## Paoli/Watson Lane Annexation

### Final Environmental Impact Report State Clearinghouse No. 2022090097

**October 2023**

Figure 2 - Proposed Prezoning

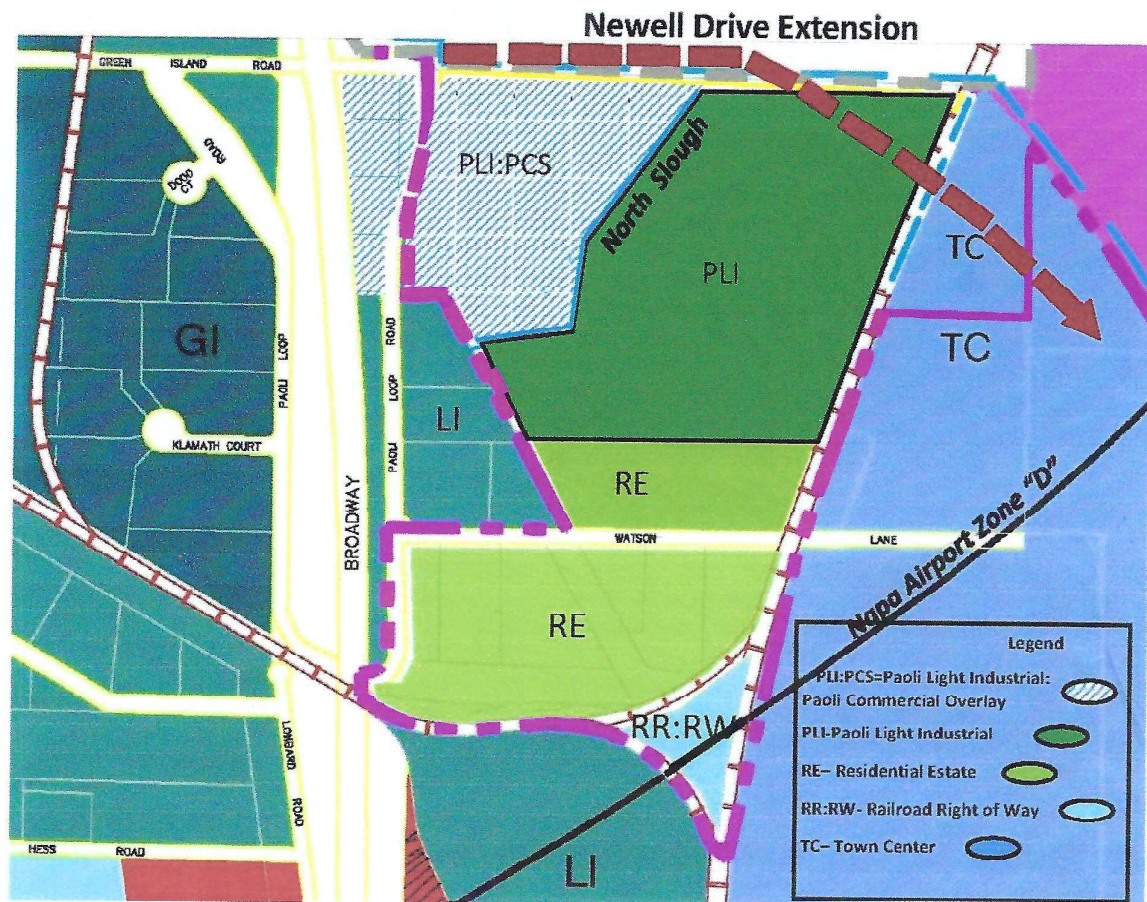
We request that the City of American Canyon Planning Commission revise its current proposed zoning for our properties as currently presented in the Environmental Impact Report to reflect the zoning as presented in the 2019 Annexation Project [see *Attachment A (2019) and Attachment B (2023)*].

The City revised the proposed pre-zoning between 2019 and commencement of preparation of the DEIR in 2022 by extending the Residential Estates pre-zoning border north to ensure that entire parcels were pre-zoned for one use. Under the 2019 proposal, pre-zoning of certain parcels in the middle of the project site (parcels I and M as indicated on Table 2-1 on page 2-4 and Figure 2-3 on page 2-5 of the DEIR) would have been split into two uses. Regardless, the proposed pre-zoning is a component of the proposed project which is outside of the scope of analysis within the DEIR. The DEIR analyzes and discloses the potential environmental impacts and mitigation measures to reduce potentially significant impacts of the proposed project. The DEIR does not propose zoning, but instead evaluates impacts of proposed zoning. Therefore, no additional revisions to the DEIR are necessary in response to this comment.
